ADDENDUM NUMBER 02

DATE: May 12, 2026

PROJECT: **CHEAHA STATE PARK FIRE STATION**

PROJECT NUMBER: **ASPD PROJECT #: 2026-005-16FS**

PROJECT NO: R08325001
 DATE: 04/17/2026
 SHEET NO: A05.10
 SCALE: AS SHOWN
 DRAWING TITLE: EXTERIOR WALL SECTIONS

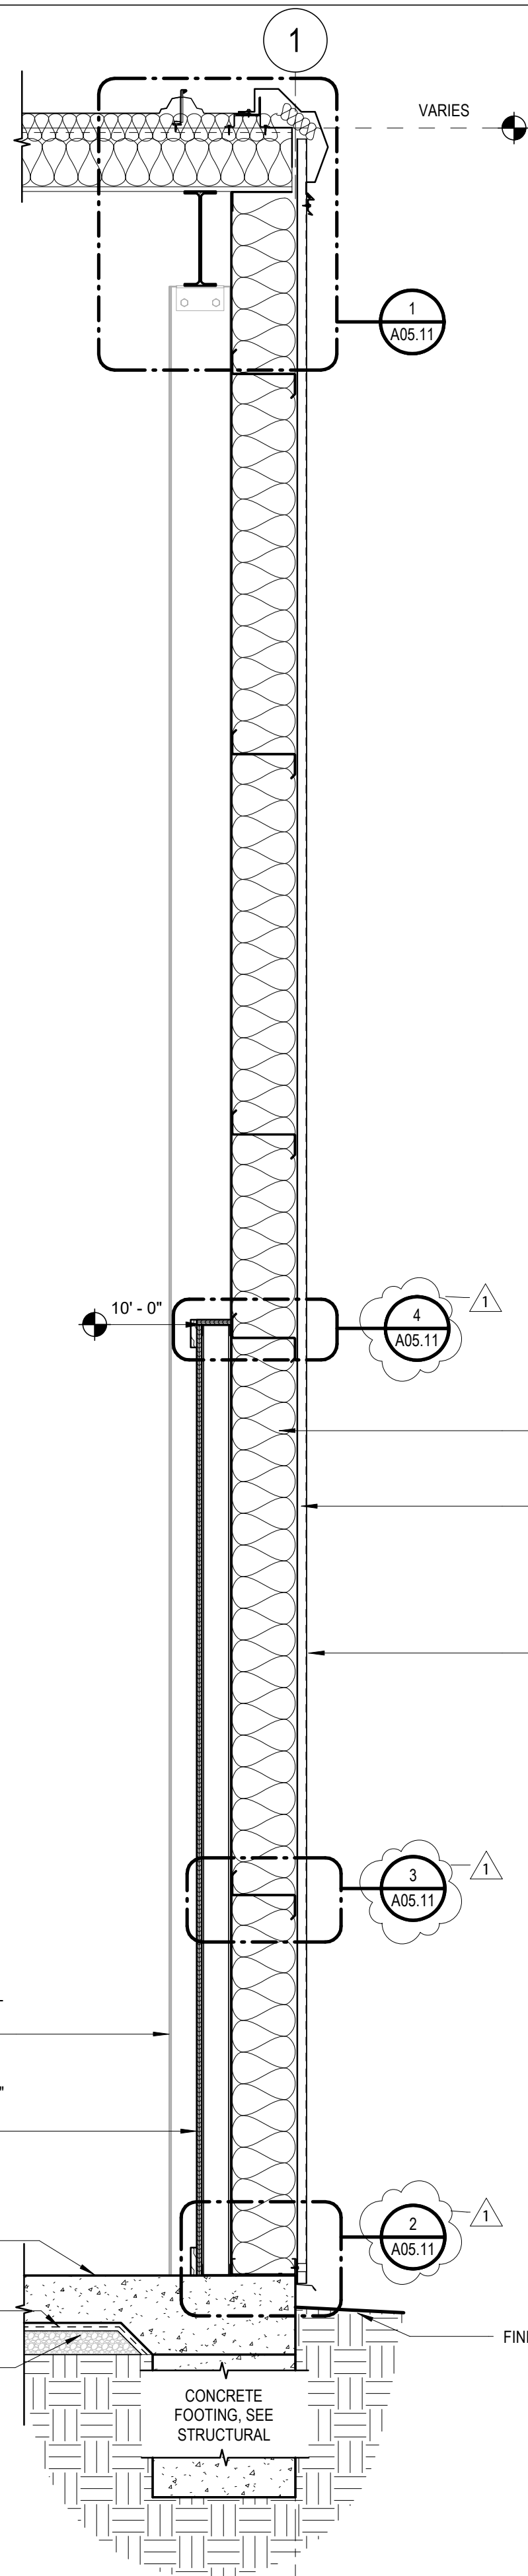
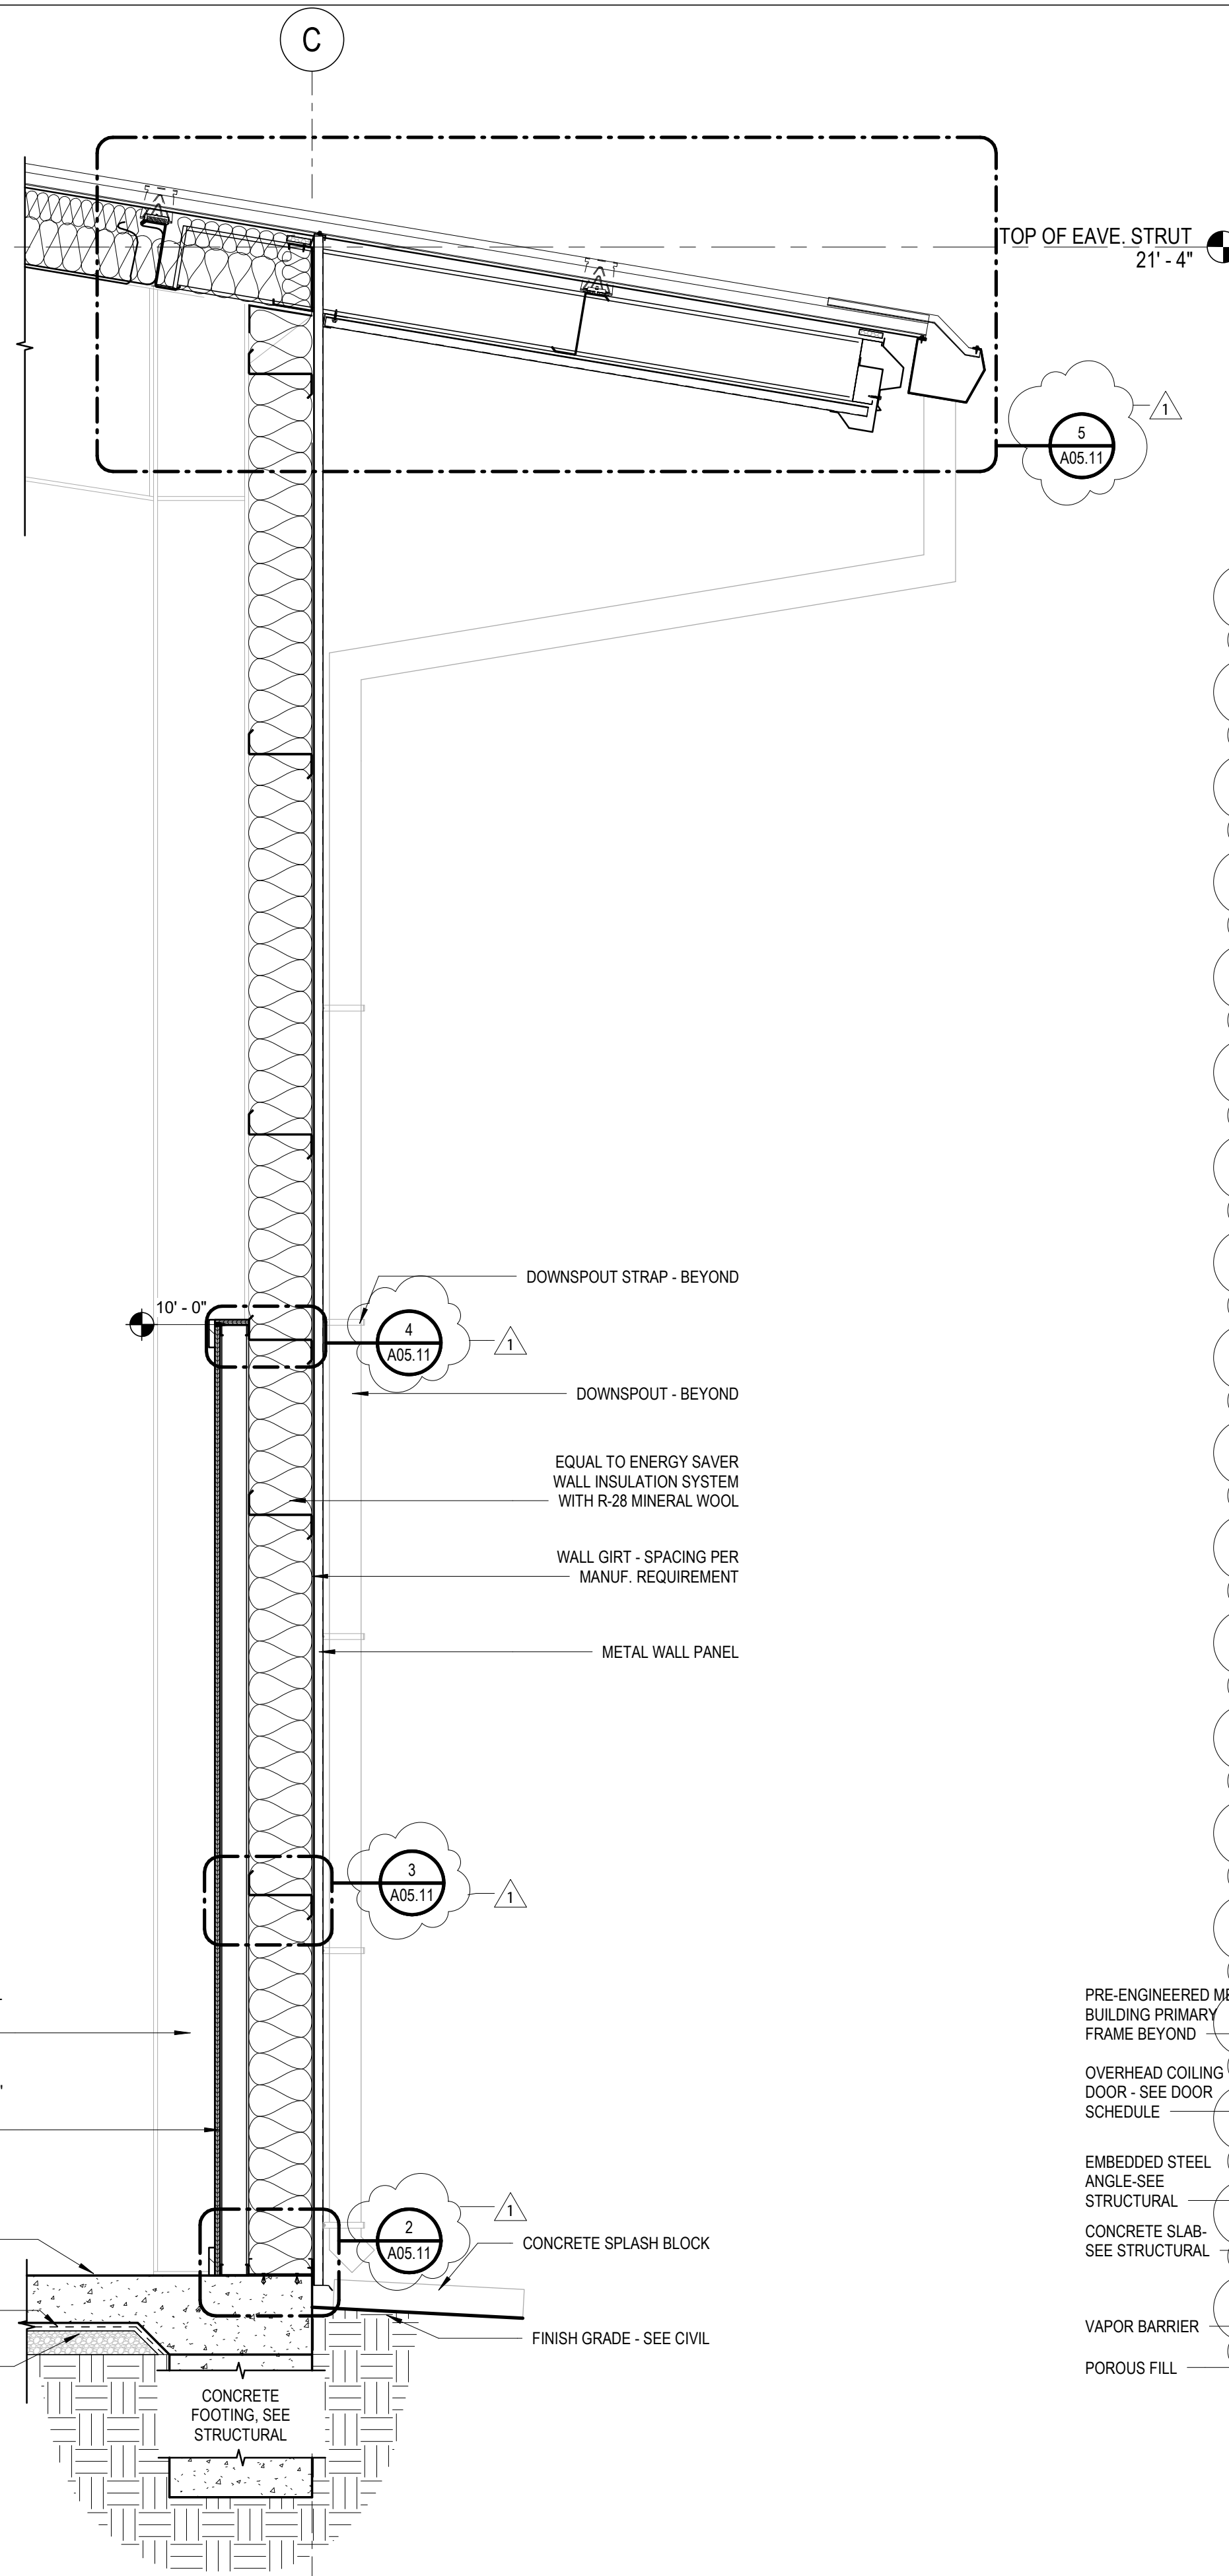
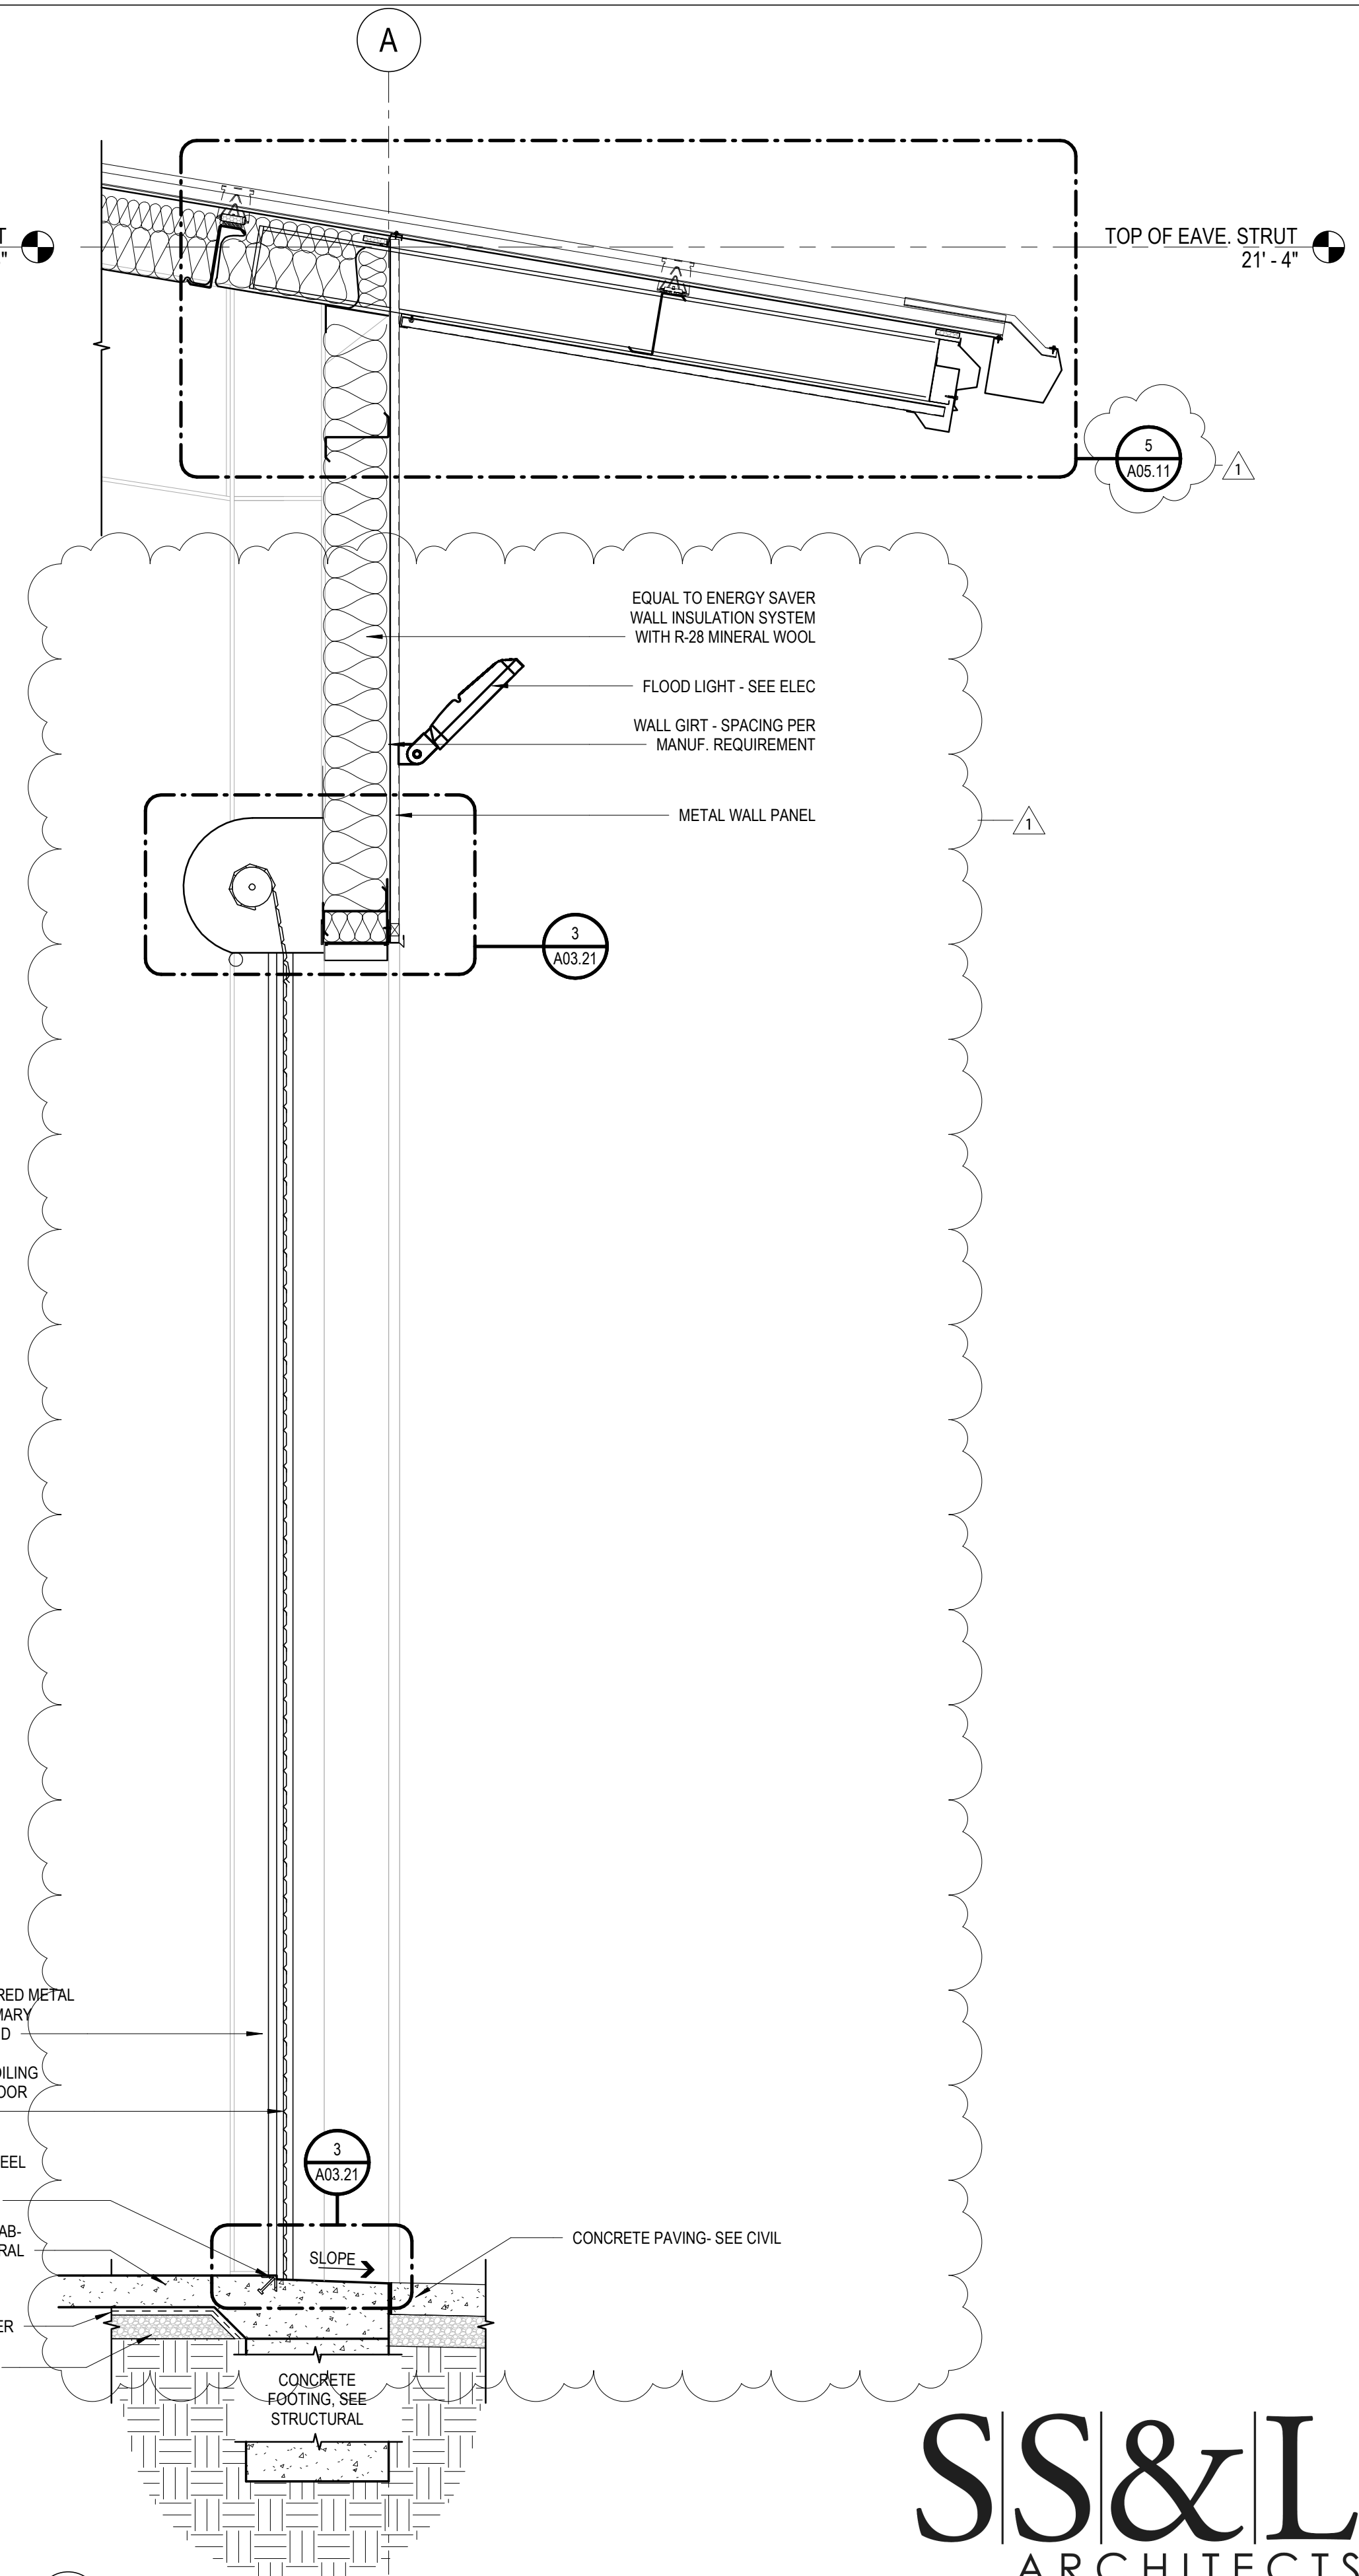
- a. Replace with the attached revised drawing.
 - b. Revision cloud reflects layout of mechanical pad.
6. **Sheet A05-10 – EXTERIOR WALL SECTIONS**
 - a. Replace with the attached revised drawing.

- b. Revision cloud reflects detail numbering change and coiling door section height shifted to match schedule.
7. **Sheet A05-11 – EXTERIOR WALL SECTIONS**
